Application Number:	2023/0500	Application Type:	Full
Proposal:	Full: Proposed dwelling	Location:	Clover Hill Greensnook Lane, Bacup Lancashire
Report of:	Planning Manager	Status:	For Publication
Report to:	Development Control Committee	Date:	19/03/2024
Applicant:	Mr & Mrs S & W Middleton	Determination Expiry Date:	25/12/23 EOT agreed to 22/03/2024
Agent:	Steven Hartley

drawing number SM-02-10-21-C(amended)

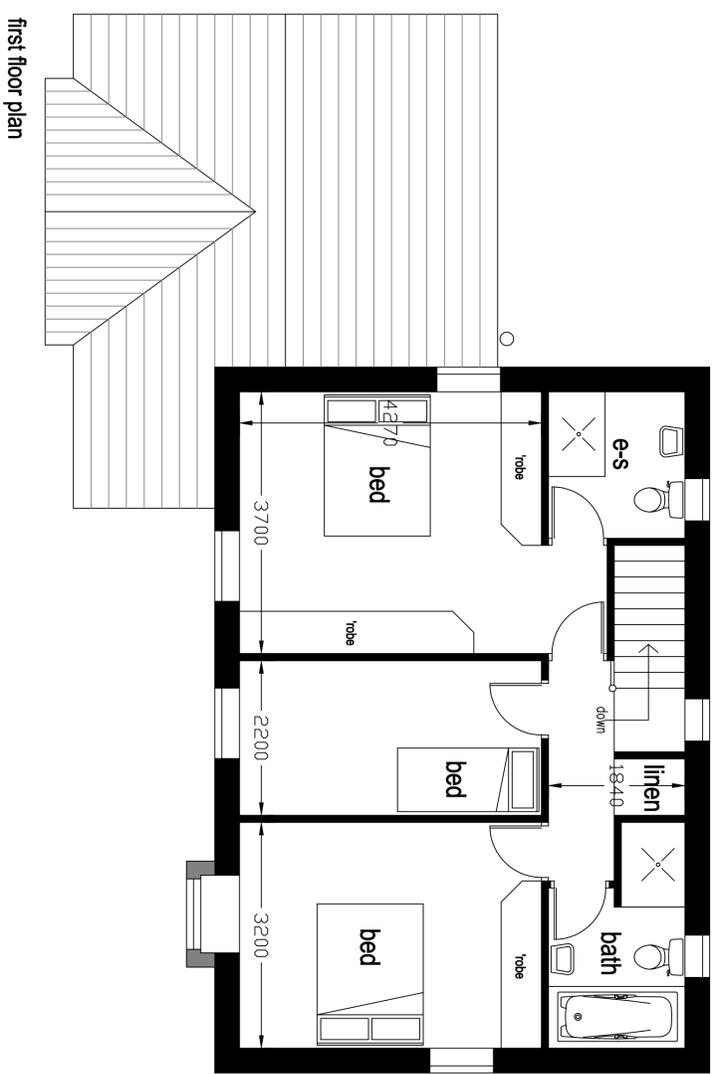
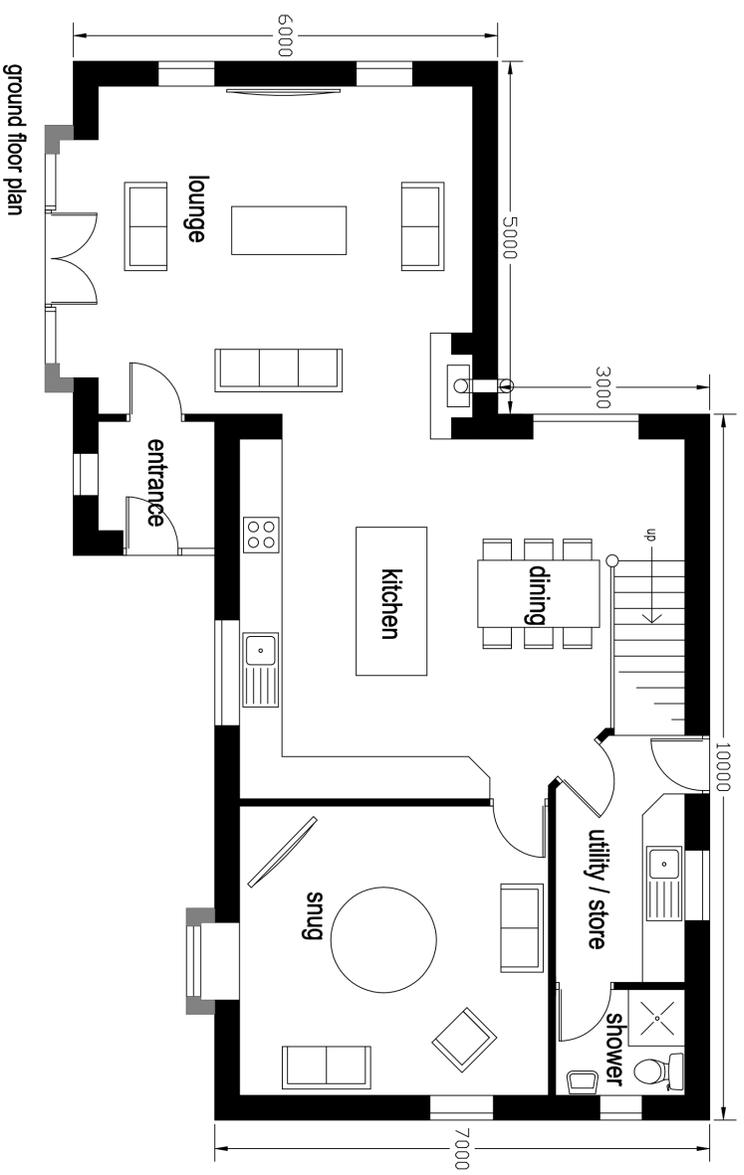
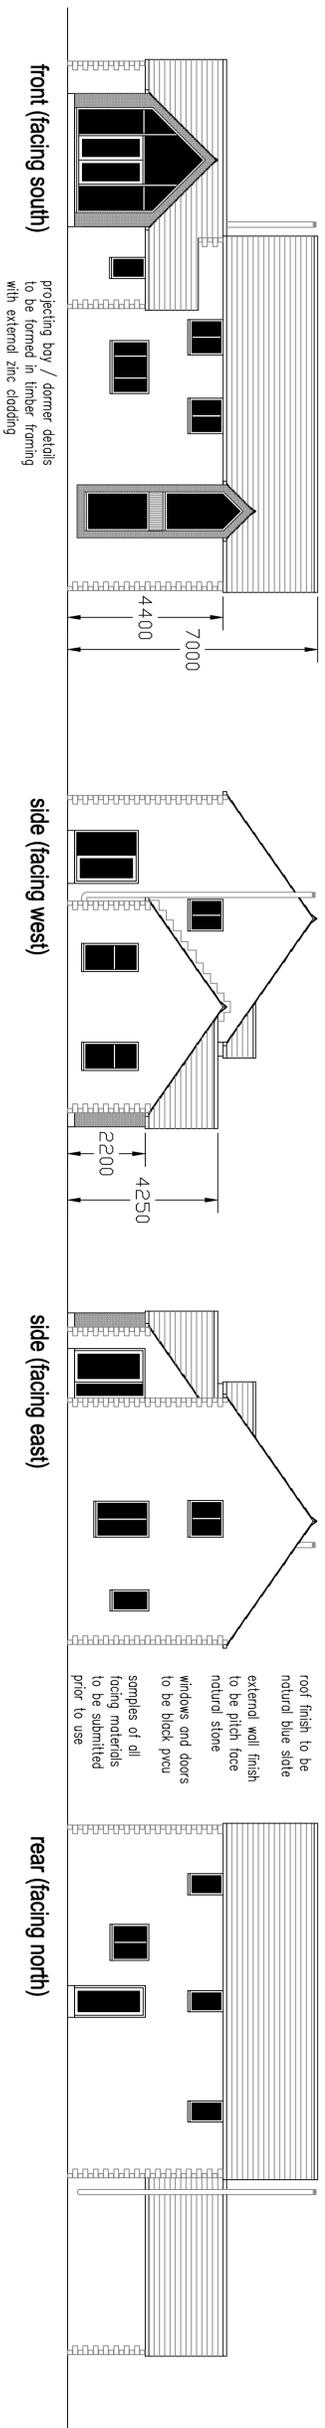
A double garage is shown on the Proposed Details Plan (Drawing SM-02-10-21-C). To count as two parking spaces a double garage should have minimum internal dimensions of 6 x 6m. This would also provide secure, covered storage for at least two cycles. The proposed double garage is sub-standard in size and cannot be counted towards the on-site parking provision. It could, however, provide secure cycle storage.

To be used as parking the minimum internal length should be 6m. This would also require the garage to be set back towards the rear boundary in order to provide the minimum manoeuvring area in front of the garage. There should be a minimum length of 6m in front of a garage where an up and over type door is fitted to allow vehicles to manoeuvre to/from the garage without overrunning the landscaped area opposite. This length can be reduced to 5.6m where a roller shutter type door is fitted.

The revised site layout plan received 4th March 2024 demonstrates that adequate on-site parking and manoeuvring can be provided in accordance with the highway authority comments. The size of the garage has been increased to 6.6 metres x 6.5 metres and two additional parking spaces adjacent with adequate manoeuvring space.

amended 01-03-24
garage depth increased

proposed site plan
 proposed detached 3 bed dwelling on land adjacent to
Clover Hill
off Todmorden Road
Bacup

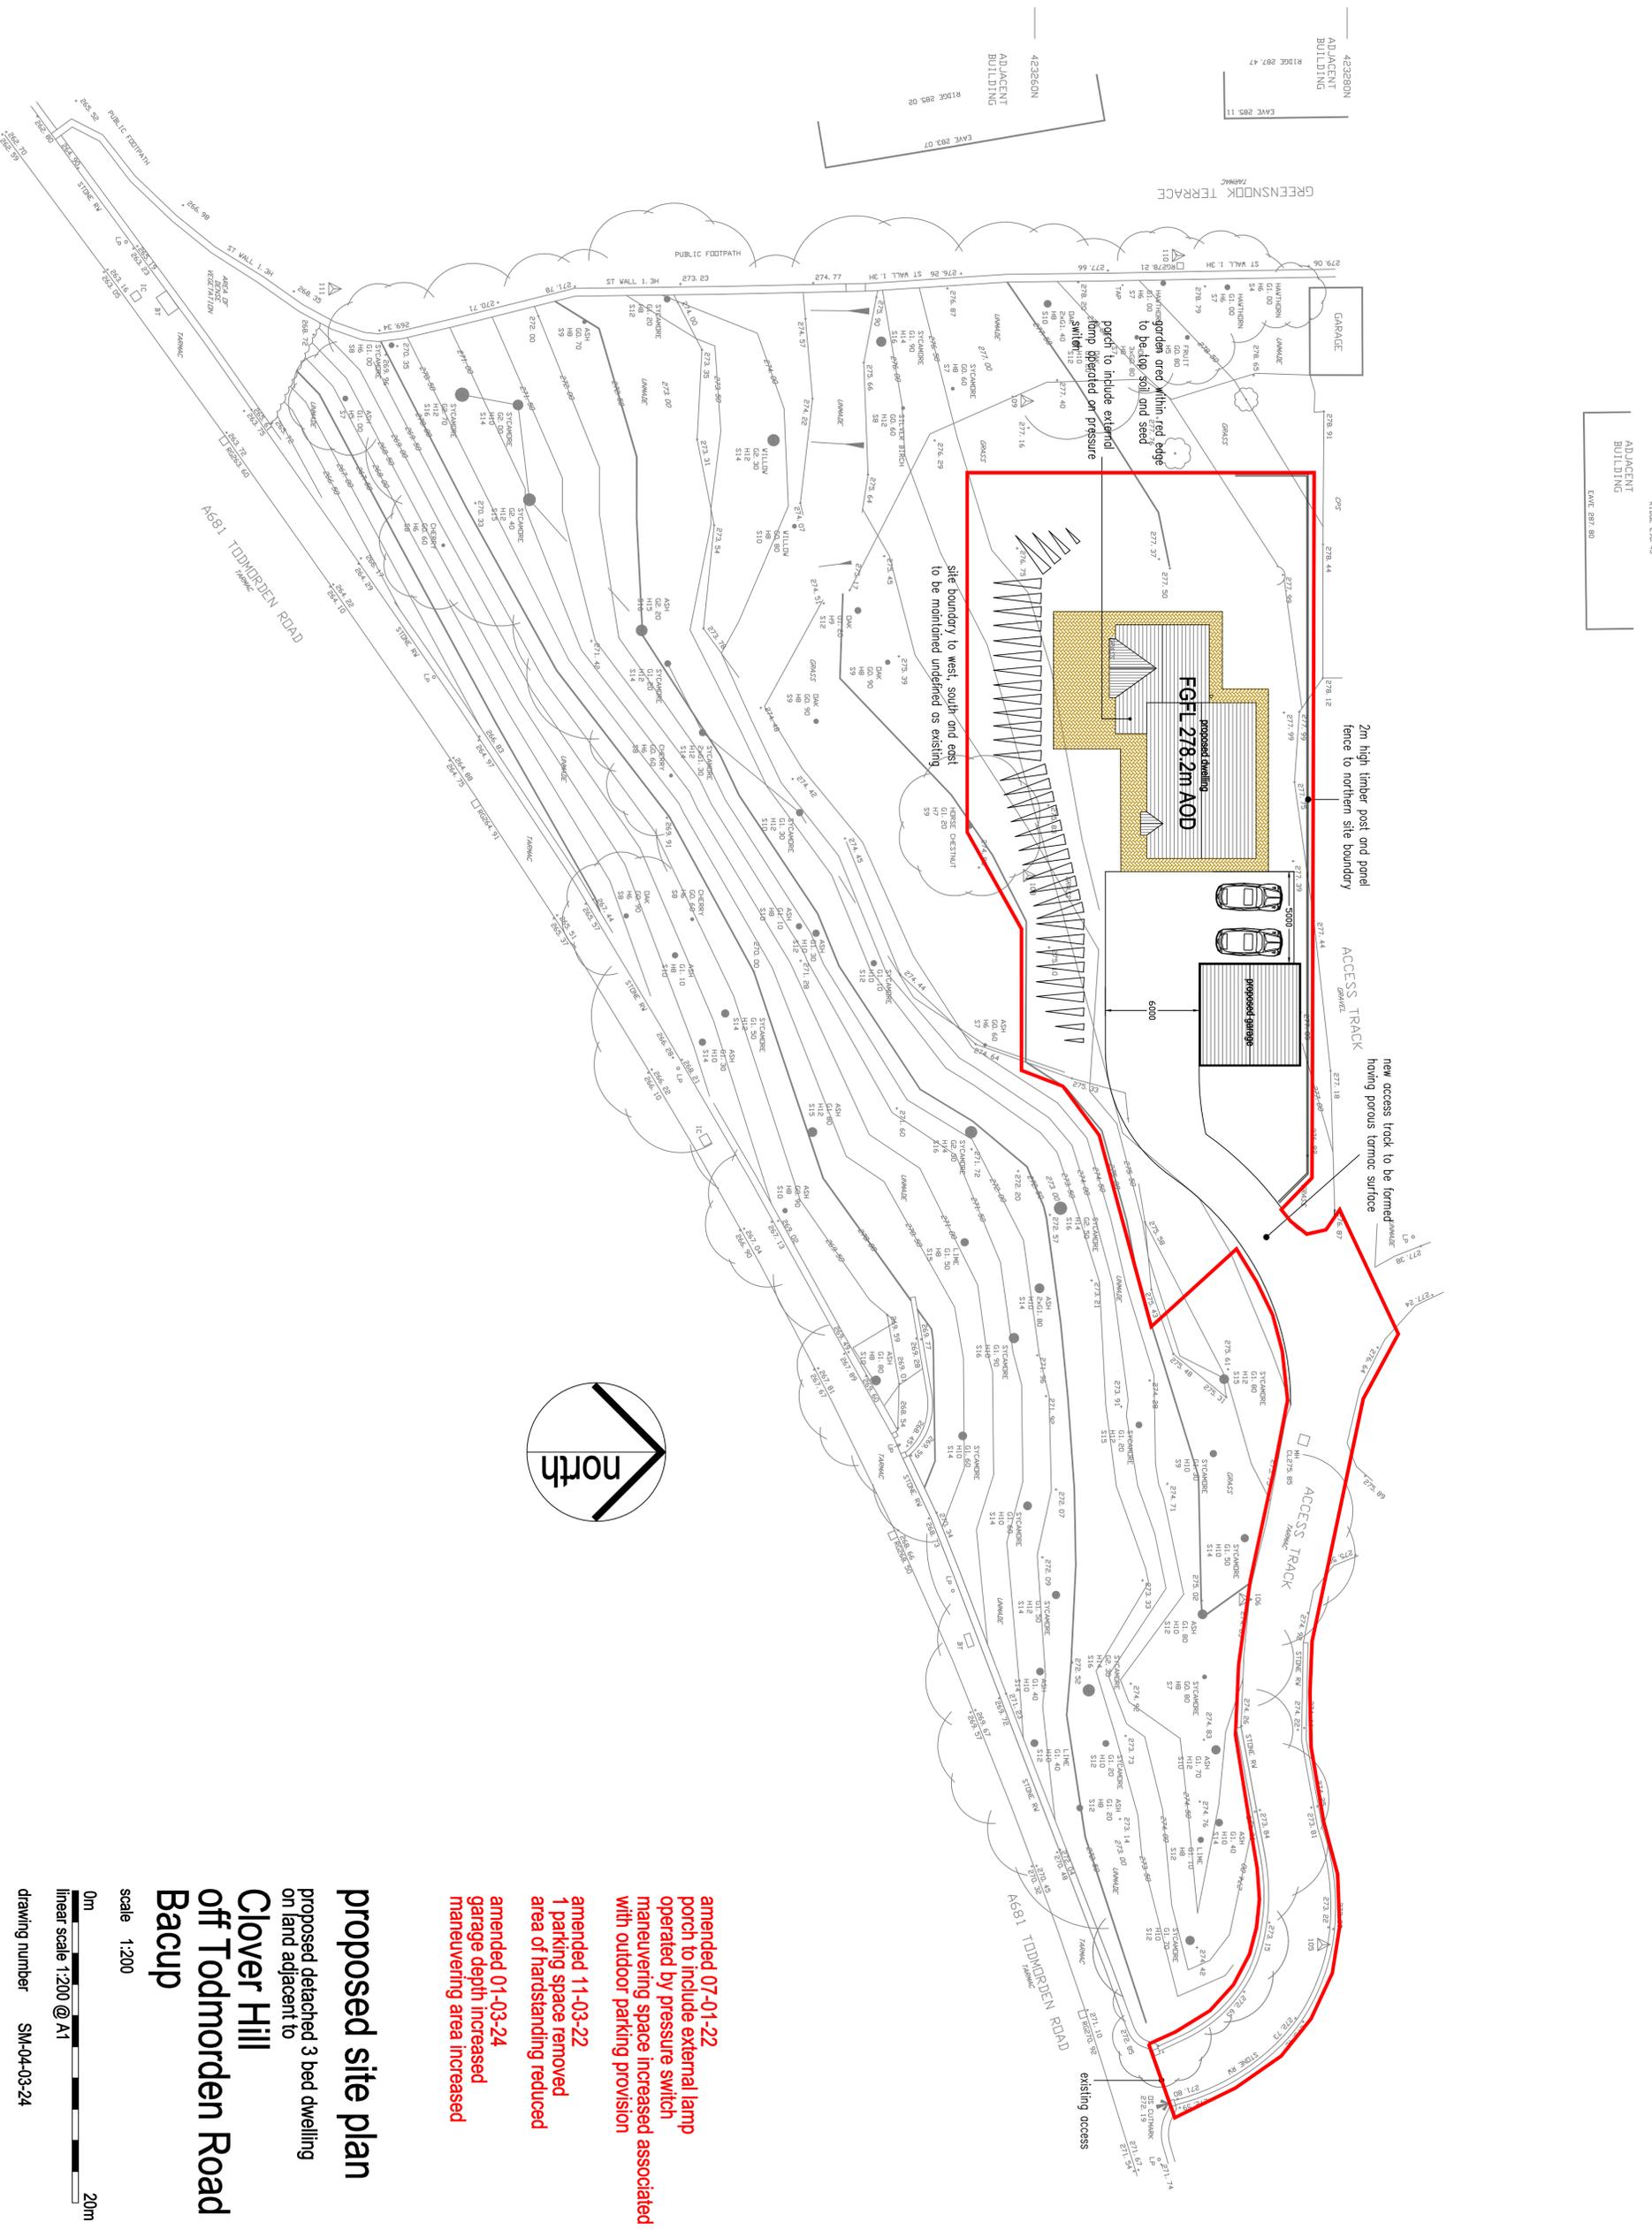
Three parking spaces are shown between the garage and the dwelling. Perpendicular parking spaces should have at least 6m manoeuvring area. The manoeuvring area shown on the Proposed Site Plan is inadequate. The parking/manoeuvring area should be extended towards the rear boundary so that a minimum overall length of 11m is provided.

A revised parking layout plan should be provided taking the above comments into account. It should be noted that a revised Proposed Site Layout Plan (Proposed Site Plan 08-01-22.B (amended)) was provided as part of the previous planning process, which demonstrated that adequate on-site parking and manoeuvring could be provided. If this drawing is re-submitted then the highway authority would consider that adequate parking provision can be provided on-site.
